[Docket No. NHTSA-99-6160]

Federal Motor Vehicle Safety
Standards; Child Restraint Systems;
Child Restraint Anchorage Systems

ACTION: Final rule, response to petitions for reconsideration.

Figure 1B

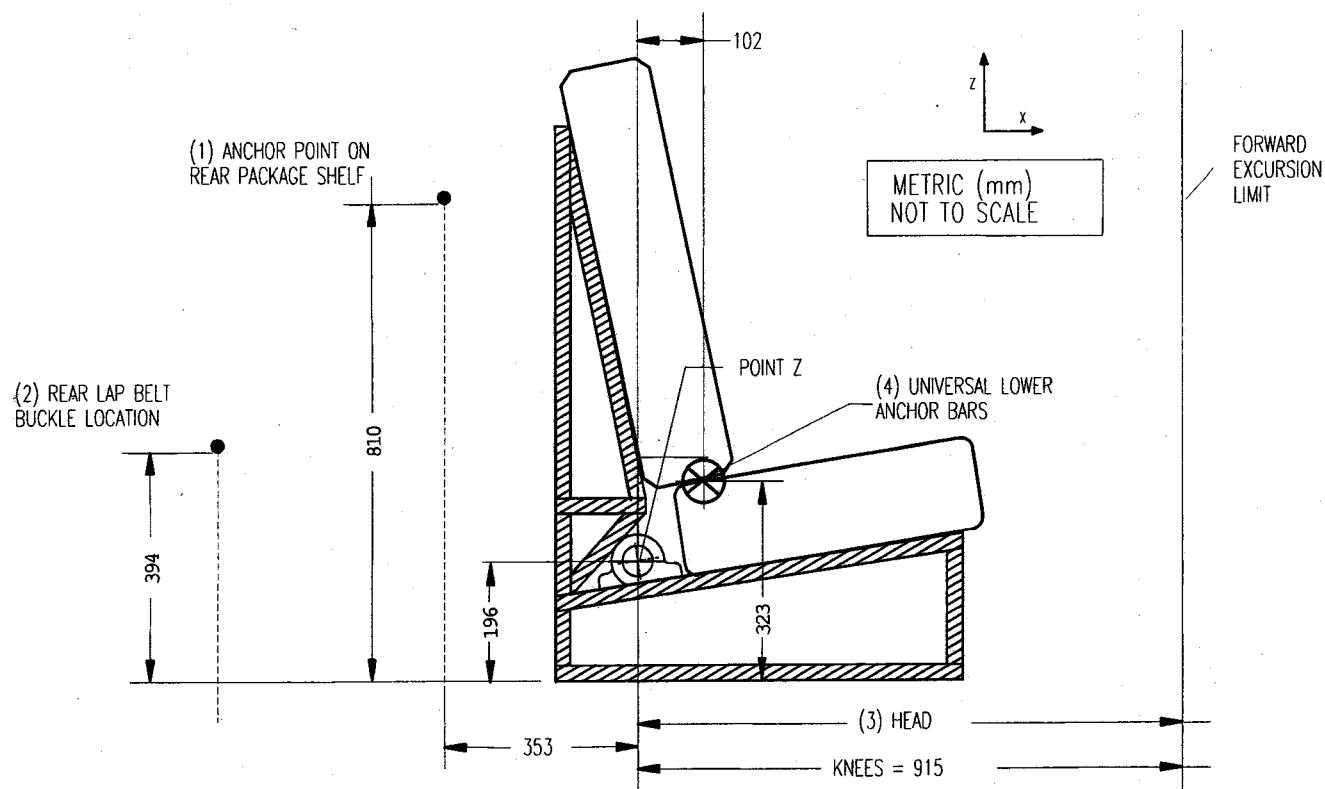
c. Figure 1B and Figure 1B’, as amended at 64 FR 10820, effective September 1, 1999, are revised.

Figure 1 – Child restraint fixture (CRF)

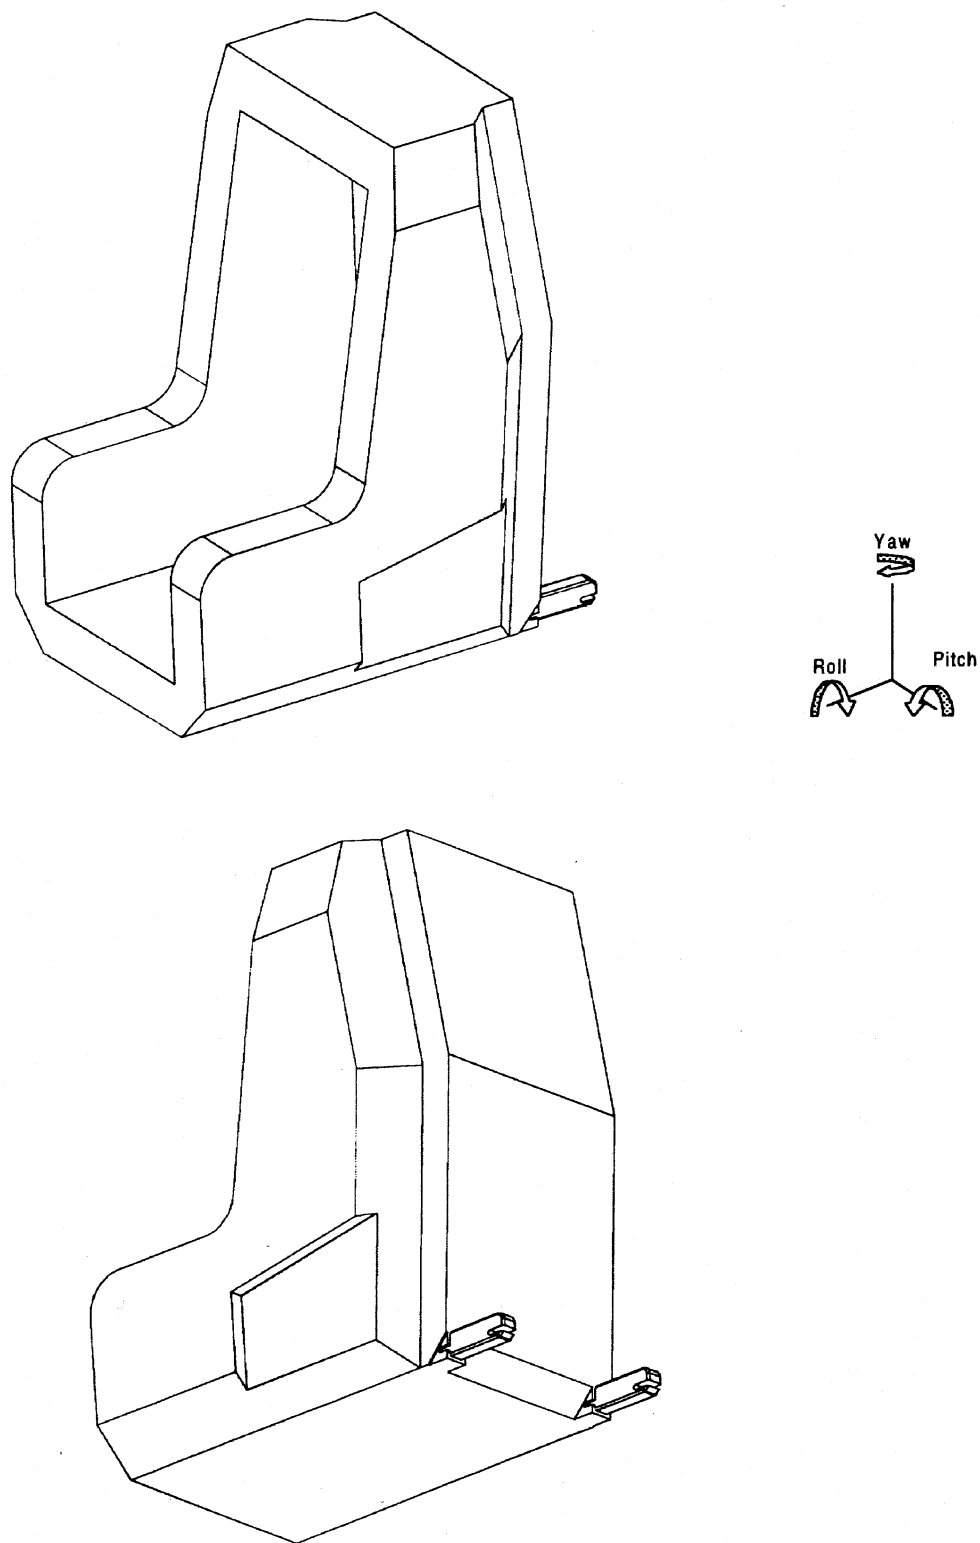
- The following figures in Standard No. 225 are corrected: Figure 1 (added yaw/pitch/roll); Figure 2 (added mass of CRF and corrected dimensions on top view); Figures 3 to 11 (darkened shading); Figure 15 and 16 (corrected dimension that Transport Canada also has on top view); Figure 17 (added 6.5 mm diameter on detail B, deleted point Y on detail A, corrected 270 dimension on side view and added stiffness details to side and back views and to note 5); Figure 18 (made force application attachment as in Figure 17); and Figure 19 (degree sign).

Figure 1A - Child Restraint Fixture (CRF) with Side and Top Frames Removed

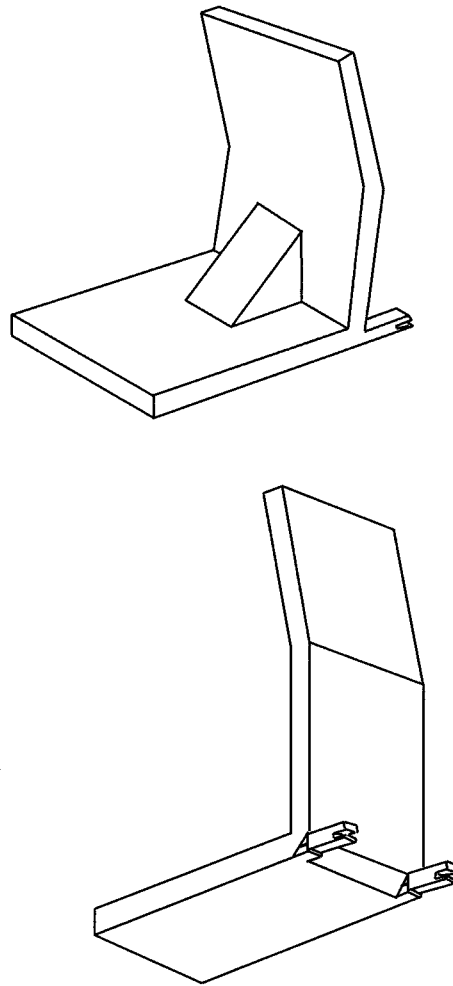
vehicle seat, the side and top frames of the CRF may be removed in order to place it in the vehicle. To illustrate the CRF with the side and top frames removed, we are adding a Figure 1A to the standard. We believe that this approach responds to Cosvam's and Toyota's concerns about the ability of their vehicles to fit the CRF in the rear seating system and makes it unnecessary to exclude vehicles as these petitioners have requested. We do not believe sufficient information has been provided to justify excluding vehicles with one or two designated rear seating positions from the requirement to provide a child restraint anchorage system at those positions. Some parents may use the vehicle to transport children regardless of a label that tells them that the vehicle is unsuitable for child restraints. (See response, above, to Cosvam's request to label vehicles.) A child restraint anchorage system in rear seating positions will provide benefits to the children using them.

(c) To facilitate installation of the CRF in a vehicle seat, the side, back and top frames of the CRF may be removed for installation in the vehicle, as indicated in Figure 1A of this standard.

Figure 17- Side, Back and Bottom Views, ISO 13216-1 Static Force Application Device 2 (SFAD 2)

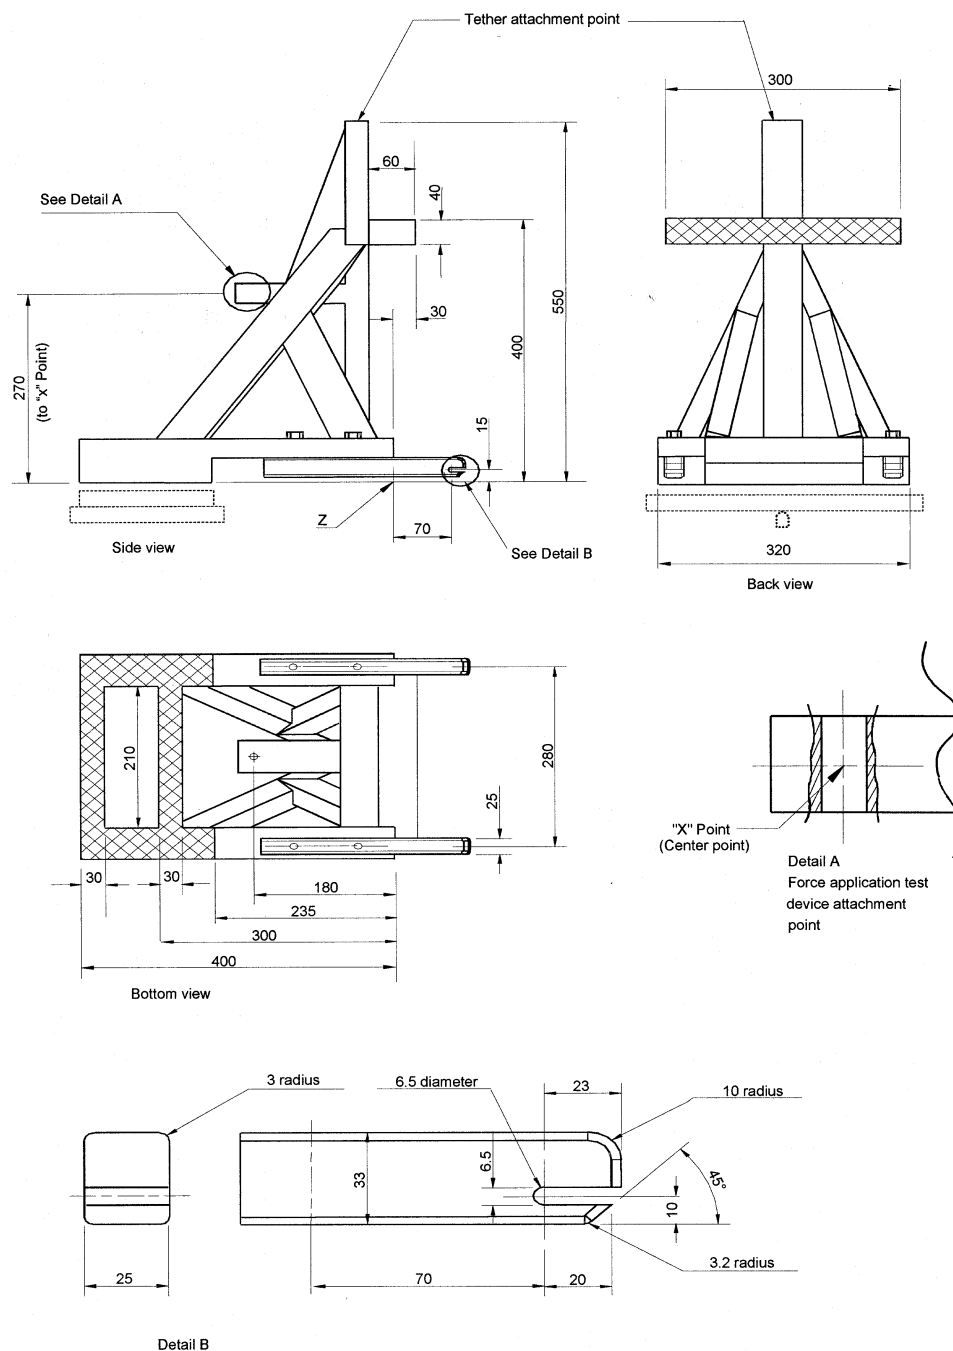
attachments that contact the lower anchor bars be specified because the shape could affect the outcome of the test. We have modified Figure 17 of the standard to show in Detail B that the rear of the slot in the SFAD 2 connecting arms has a diameter of 6.5 mm. The petitioner also suggests that a stiffness specification for SFAD 2 be added as in the draft ISO standard, to ensure that the test fixture is sufficiently strong to withstand the forces in the test. We have added a stiffness specification, from the draft ISO standard, to Figure 17.
